DUKE POWER COMPANY

Re: Oconee Nuclear Station, Unit 1
Docket No. 50-269

ATTACHMENT 1

BAW-1493
OCONEE UNIT 1 - CYCLE 5
RELOAD REPORT

Figure 2.3-2A

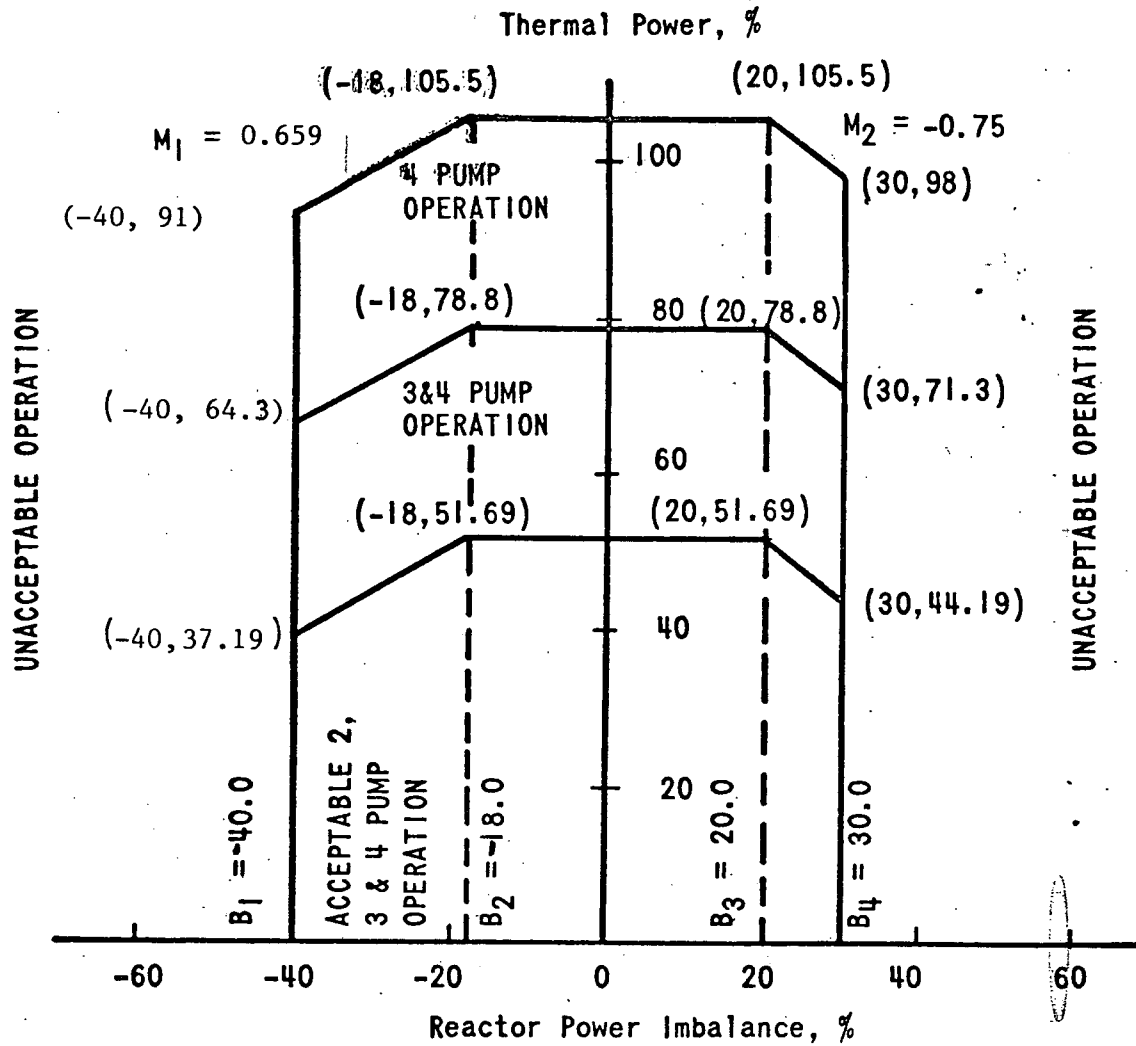
TECHNICAL SPECIFICATION PAGE
FIGURE 2.3-2A

PROTECTIVE SYSTEM
 MAXIMUM ALLOWABLE SETPOINTS
 UNIT 1
